EASTERN CORRIDOR SEGMENTS II and III (PID 86462)

Excerpts from Conceptual Alternatives Implementation Plan

CONCEPTUAL ALTERNATIVES IMPLEMENTATION PLAN

Eastern Corridor Segments II and III PID 86462

Eastern Corridor Multi-Modal Projects
Segment II-III (SR 32 Corridor)
HAM-32F-0.00; PID 86462 Figure BIKE-2A

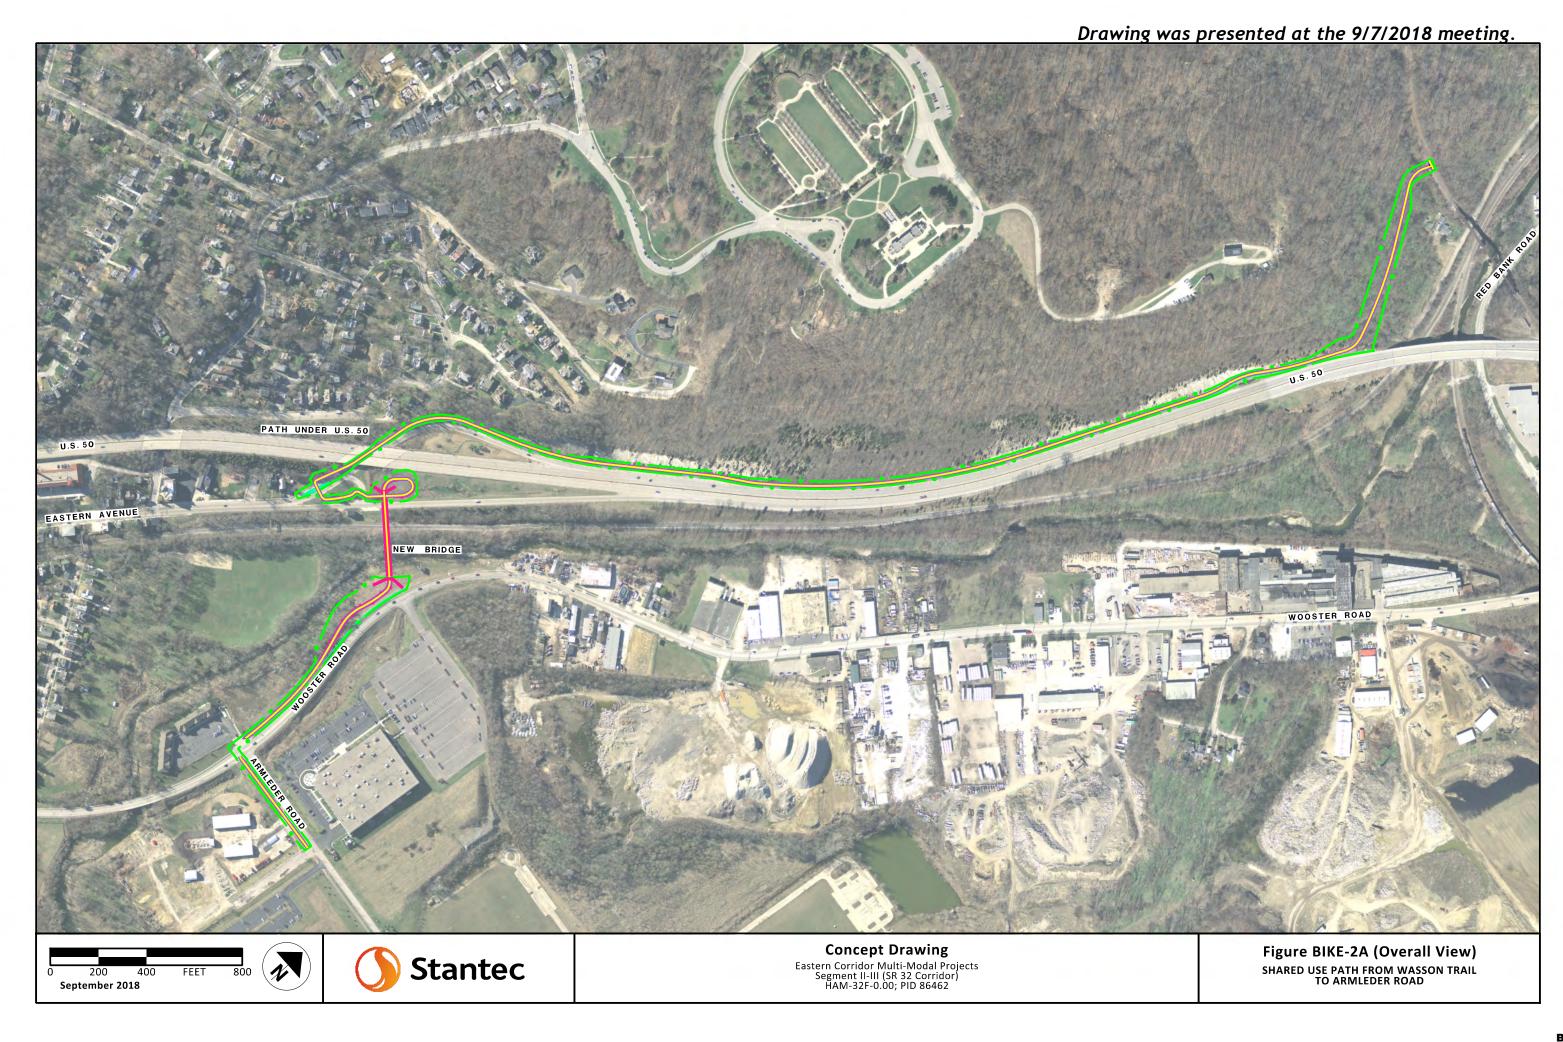
- A barrier-protected shared-use path would be located along right side of westbound US 50.
- The path would follow the existing exit ramp (5% grade) from US 50 to Eastern Avenue, then cross to Armleder Road using the connection established in the BIKE-1 concept.
- No additional comments received following the 5/22 meeting.

- This concept requires construction of a new bridge crossing from Eastern Avenue to Wooster Road. The bridge would be located immediately east of Linwood Park.
- A shared-use path located next to US 50 would need to be separated by a physical barrier; concrete barriers are proposed. Installing concrete barriers would not impact the hillside or shoulder along US 50, but would require modification of the city gateway.
 - One Committee member expressed concern that cyclists would be traveling a long way without an option to exit the path. Another

suggested that, even with the concrete barrier, cyclists might not feel safe, particularly with children traveling so close to vehicular traffic on US 50.

- This project would connect the bike path to Ault Park's hiking trails, which opens up a larger commuter network to local neighborhoods.
- Consider incorporating the spur to the Murray Trail (as outlined in concepts E6/E7) into this concept.
- The priority of this concept will depend on the status and advancement of the Wasson Way trail.

- Include in the Implementation Plan as a medium priority, including BIKE-2a and BIKE-1a to fully connect Wasson Way Trail to Armleder Park.
- Consider connecting Murray Trail spur.

Eastern Corridor Projects
Segment II-III (S.R. 32 Corridor)
HAM-32F-0.00; PID 86462 Figure BIKE-2B Stantec SHARED USE PATH CONNECTION BETWEEN WASSON TRAIL AND ARMLEDER TRAIL September 2018

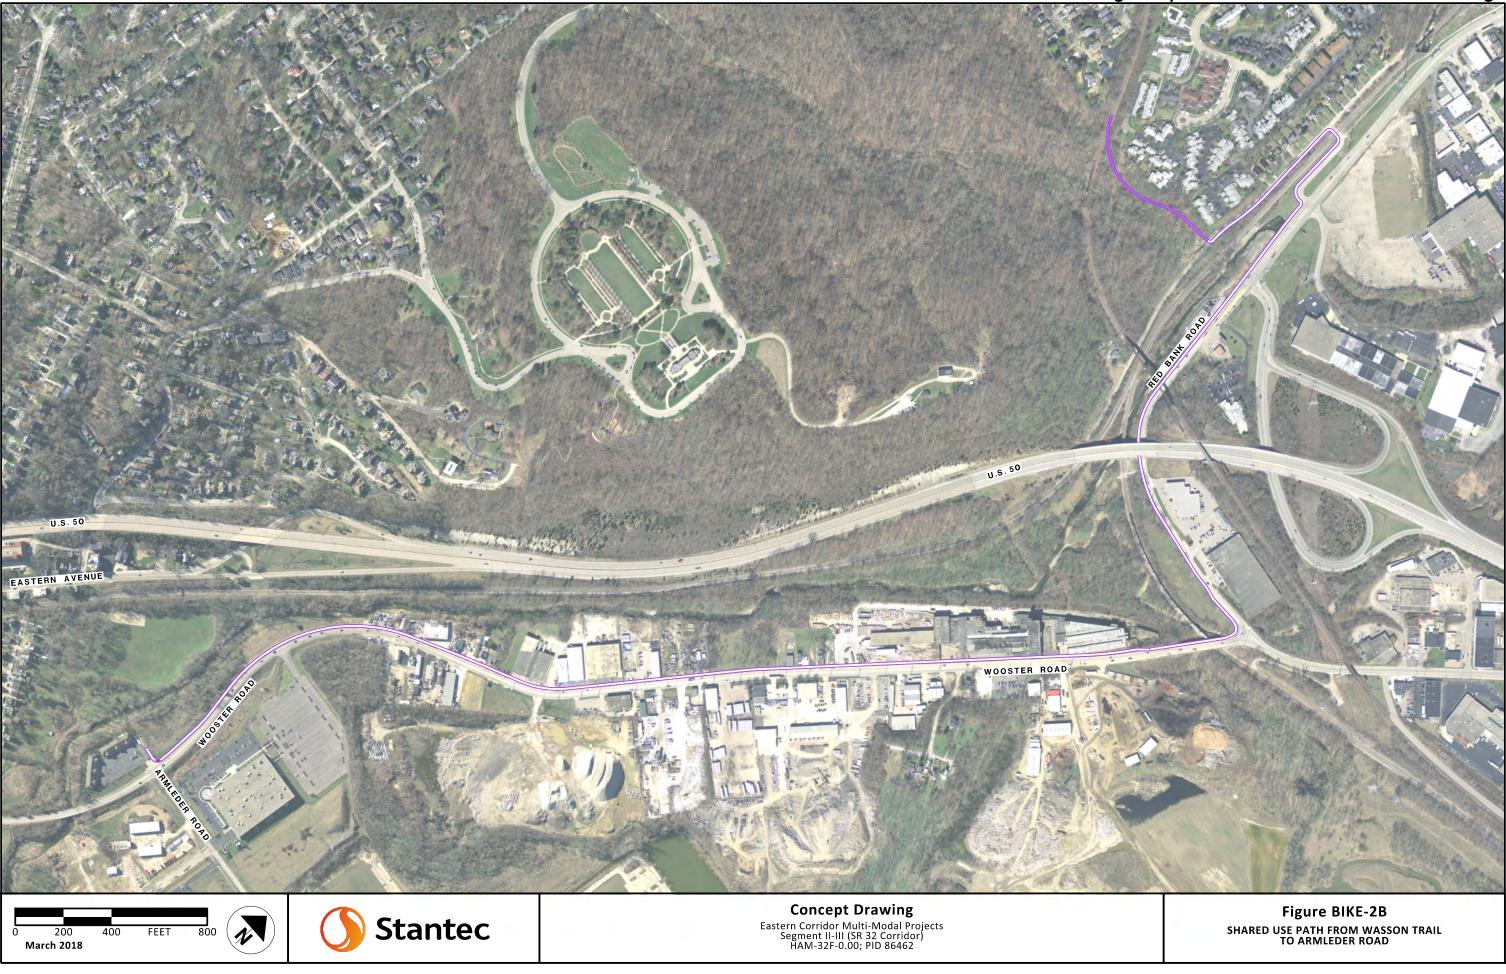
- An on-street bike path on Wooster would be challenging because businesses are located close to the road on both sides in this area.
- Commercial use of the road would make it a challenge to keep the bike path clean. Road debris (gravel, dirt, sand, trash, etc.) would likely collect in the bike path.
- Running the bike path behind the businesses located on the north side
 of Wooster may be a challenge. Space availability is limited by a creek
 and old rail tracks (not used since 1982) and buildings. Ownership of
 the rail tracks may be split between SORTA and Norfolk Southern.
- The consultant team will confirm whether routing a bike path behind businesses on the north side of Wooster may be an option.
- The consultant team will determine who owns the railroad tracks in this area.
- No additional comments received following the 5/22/18 meeting.

- This concept would be part of a phased-approach to connecting the Wasson Way Trail to Armleder Road using X-4d-1 (Wooster extension to Colbank with roundabout at Red Bank Road and Wooster Road) and BIKE-4a or BIKE-4b.

- The path would connect with the gravel path in Ault Park, drop under the railroad trestle at the back of the park and go north parallel to Old Red Bank road, then over the creek before turning south to follow along the new X-4d or X-4d-1 connector.

- A Committee member asked if instead of following the new connector, would it be possible to continue the path along Old Red Bank Road US 50 of the US 50 ramp. ODOT shared that there is an existing abutment wall under US 50 that is a barrier to a bike path connection.

- Of the three bike path options in this area [BIKE-2a (E5), BIKE-4b (E6) and BIKE-4a (E7)], E6 received the highest amount of support from the public.
 - The committee surmised that this is because, as drawn, the bike path would travel along a vegetated corridor and creek before linking with the Armleder bike path.
 - H. Hafner & Sons expressed concern with having the bike path

- cross the company's driveway. They reported that 800 trucks come in and out of the driveway on a daily basis and it is hard to see bikes from the trucks. There is also typically a lot of debris in area.

- E6/E7 estimates do not include the cost of constructing the proposed roundabout at Wooster and Red Bank. If that cost were to be added, the estimates for each would be closer to the cost estimates for concept BIKE-2a (E5).

- The committee discussed eliminating BIKE-4b (E6) due to the concerns of connecting the bike path across the Hafner driveway.
- The committee agreed that concept BIKE-4a (E7) needs to include the proposed roundabout at Wooster and Red Bank. Therefore, the cost estimates for the roundabout should be added to the estimate for BIKE-4a (E7). This will increase the cost significantly. Even so, the committee agreed that this option should still be included in the Implementation Plan for future consideration.

- No further study on concept E6.
- Include E7 in the Implementation Plan as a medium priority. This includes a connection from Wasson Way Trail to Murray Trail, a shared-use path on the X-4d-1 alignment without the roadway improvements and the roundabout at Wooster and Red Bank.

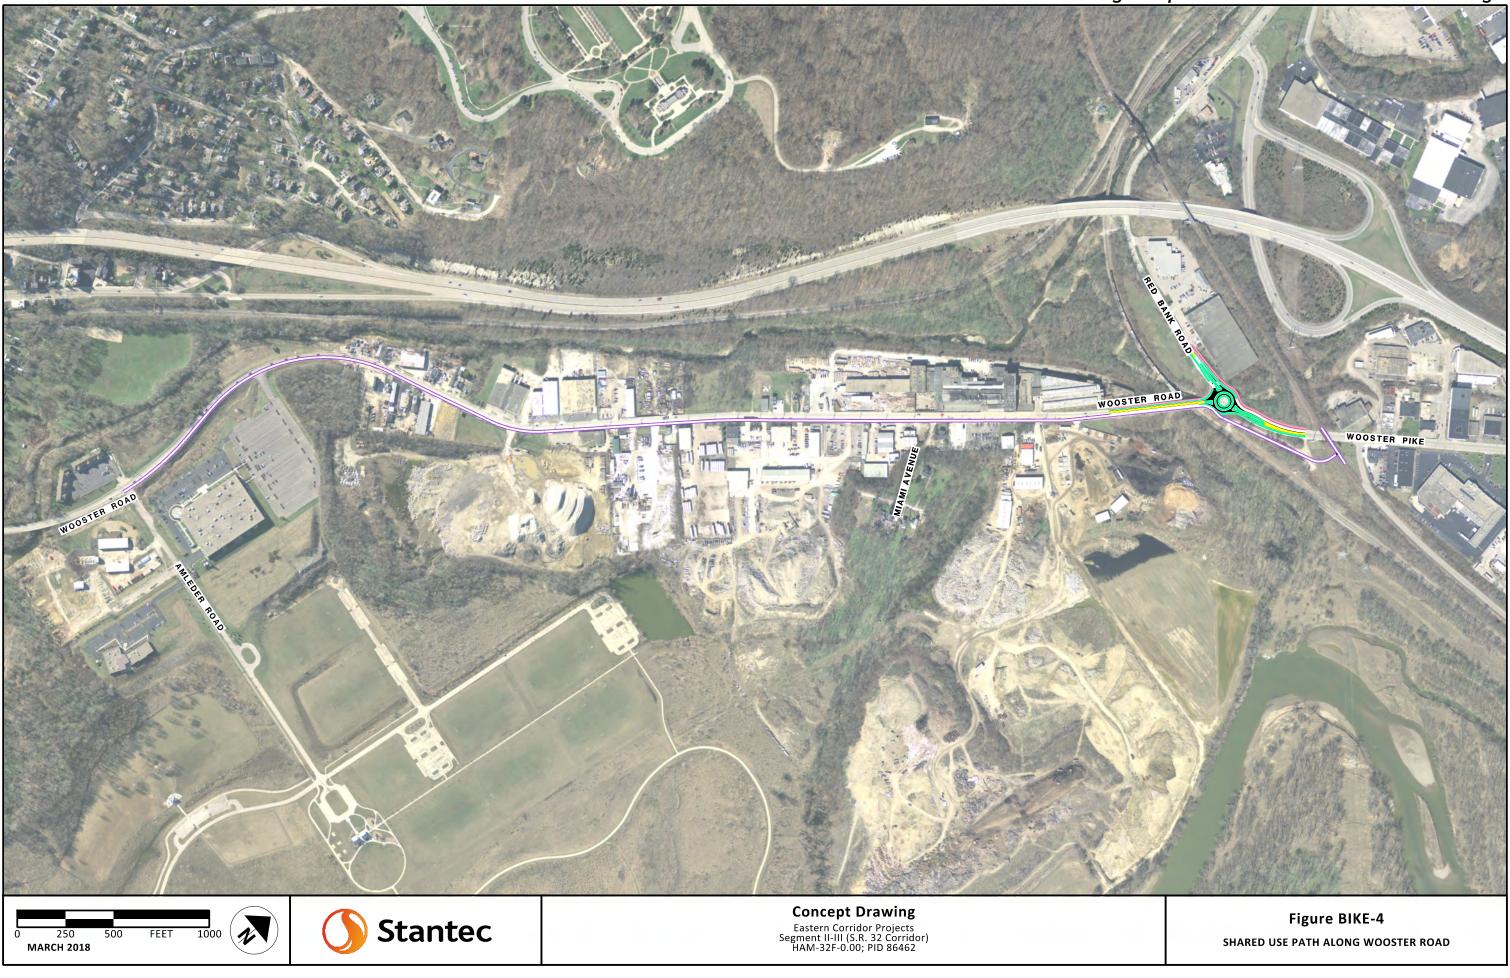
Figure BIKE-4 shows a bike trail extension across Wooster towards Mariemont Avenue near the Mariemont Industrial District. Any proposed bike paths in Mariemont will require Village approval. Also, not bike path information has been provided for the US 50 segment. Mariemont reserves the right to additional comments as this information becomes available from ODOT.

- Concept advanced as BIKE-4a and BIKE-4b (described on following pages).
- No additional comment received following the 9/7 meeting.

• Incorporate concept into BIKE-2b; BIKE-4a becomes part of BIKE-2b (E7), while BIKE-4b becomes part of BIKE-2b (E6).

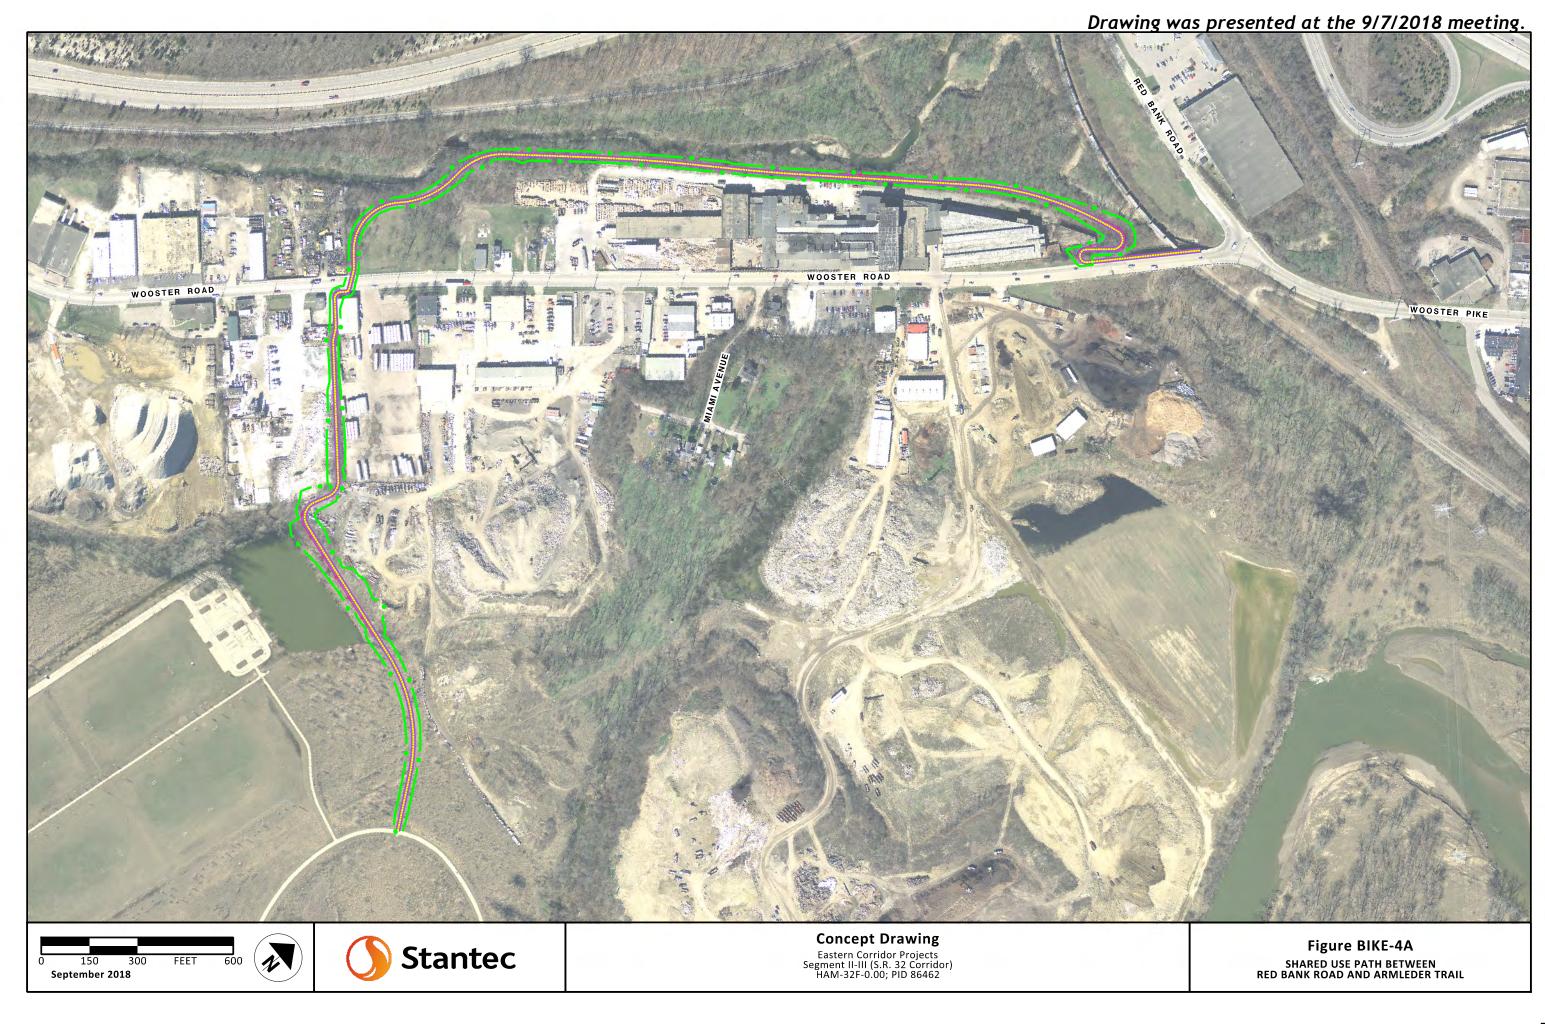
- This concept could be combined with X-4d-1 (Wooster extension to Colbank with roundabout at Red Bank Road and Wooster Road) and BIKE-2b to connect the Wasson Way Trail to the Armleder Trail Loop.
- This concept would include a mid-block crossing on Wooster (west of Cincinnati Paperboard's greenspace) with a rectangular rapid flash beacon (RRFB).
- Running the shared-use path behind Cincinnati Paperboard but south of the creek is a tight fit.
- A Committee member asked if it might be possible to take the trail through the existing Norfolk-Southern railyard in Mariemont (Clare Yard). It was reported however, that that area is being preserved for potential future rail use.
- A Committee member asked whether it was possible to rate Concept BIKE-4a and BIKE-4b as to which is more feasible from a construction

standpoint. Additional engineering analysis would be required in order to make that determination.

- Of the three bike path options in this area (E5, E6 and E7), E6 received the highest amount of support from the public.
- The committee surmised that this is because, as drawn, the bike path would travel along a vegetated corridor and creek before linking with the Armleder bike path.
- H. Hafner & Sons expressed concern with having the bike path cross the company's driveway. They reported that 800 trucks come in and out of the driveway on a daily basis and it is hard to see bikes from the trucks. There is also typically a lot of debris in area.
- E6/E7 estimates do not include the cost of constructing the proposed roundabout at Wooster and Red Bank. If that cost were to be added.

- The committee discussed eliminating E6 due to the concerns of connecting the bike path across the Hafner driveway.
- The committee agreed that concept E7 needs to be include the proposed roundabout at Wooster and Red Bank. Therefore, the cost estimates for the roundabout should be added to the estimate for E7. This will increase the cost significantly. Even so, the committee agreed that this option should still be included in the Implementation Plan for future consideration.
- The priority of this concept will depend on the status and advancement of the Wasson Way trail.

• Include in the Implementation Plan as part of E7 as a medium priority.
